West Rankin Utility Authority | Administration Building
WBA Project No. 5719

ADDENDUM NO. 02

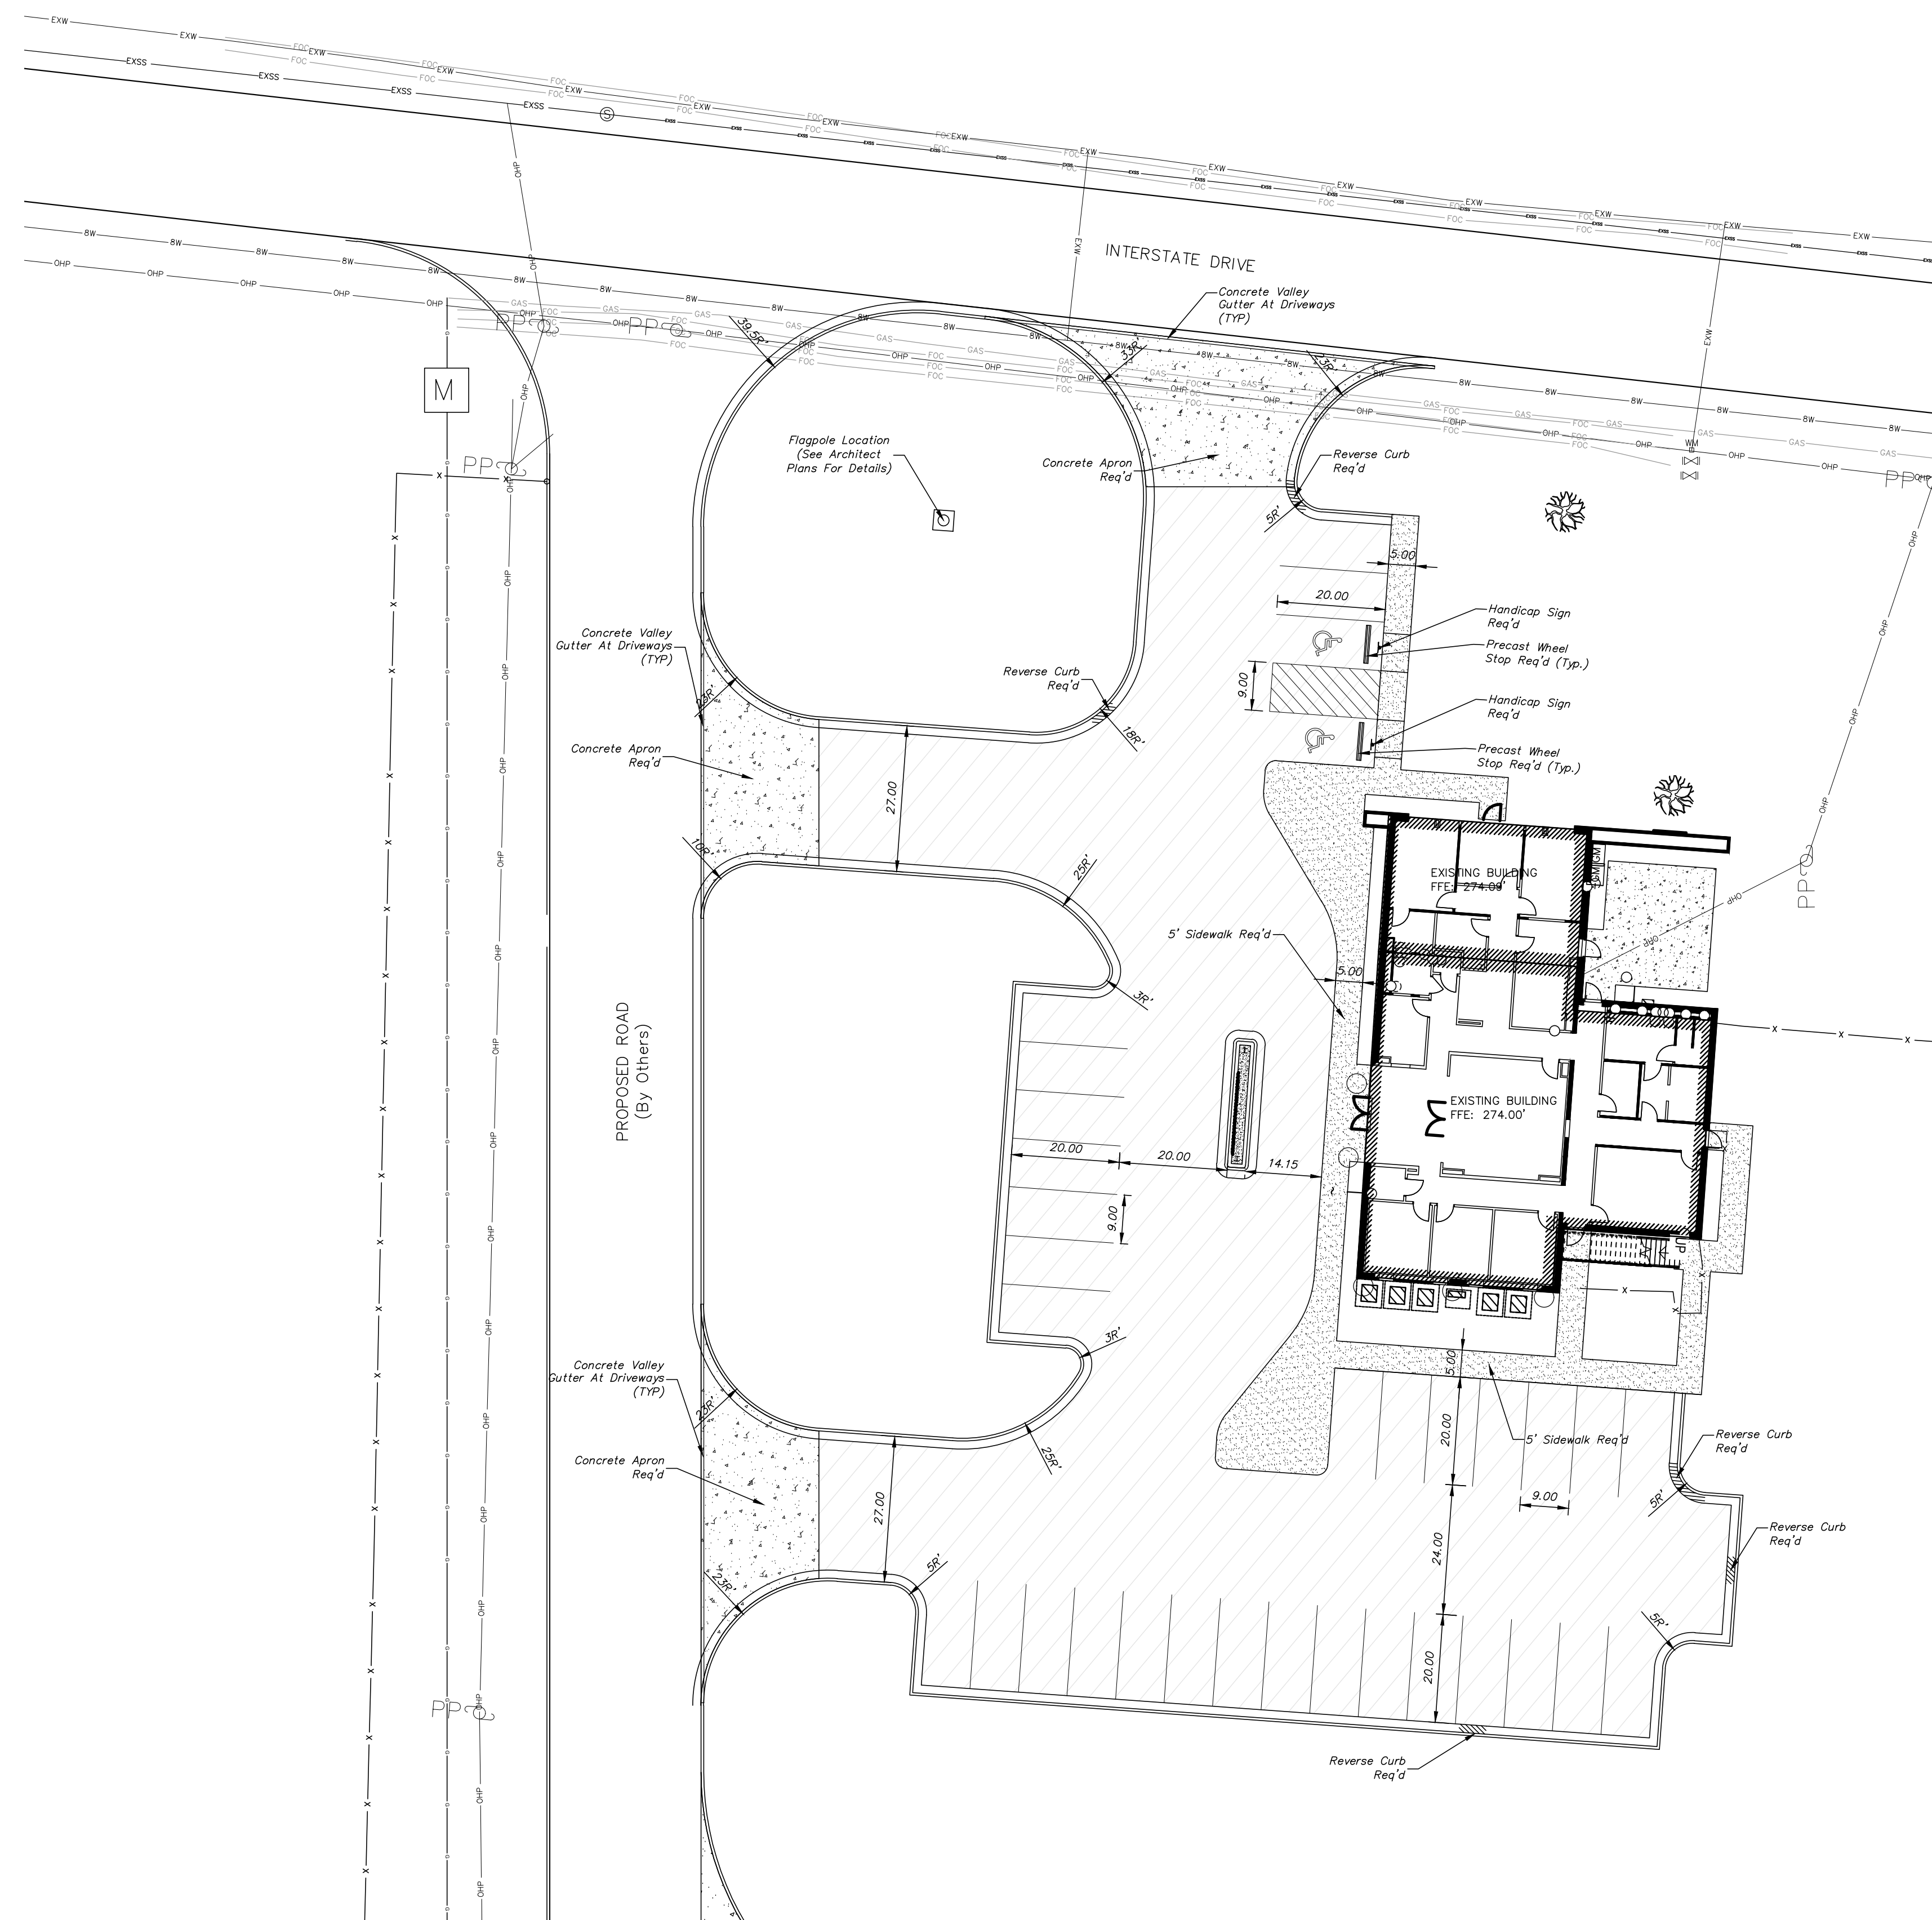
- ITEM NO. 3** **SHEET C201 Site Plan**
ADD indication for extent of asphalt paving.
- ITEM NO. 4** **SHEET C302 Storm Drainage Layout**
DELETE 8'-0" section of storm drainage pipe.
- ITEM NO. 5** **SHEET D100 Demolition Plan**
ADD Demolition Keynote 16 – Remove split-faced concrete block at exterior of lower level office.
ADD Demolition Keynote 17 – Remove roof overhang at north end of lower level as required for new construction. Maintain weather tightness at exposed edge.
- ITEM NO. 6** **SHEET A501 Doors and Windows**
ADD note to DOOR SCHEDULE: Access control will be keypads and devices provided per door hardware allowance. All installation provisions to be provided in base bid.
- ITEM NO. 7** **SHEET A501 Floor Plans**
REVISE sink location in SAMPLES 119

NO.	DESCRIPTION	DATE
2	Added asphalt	5/22/20 to legend
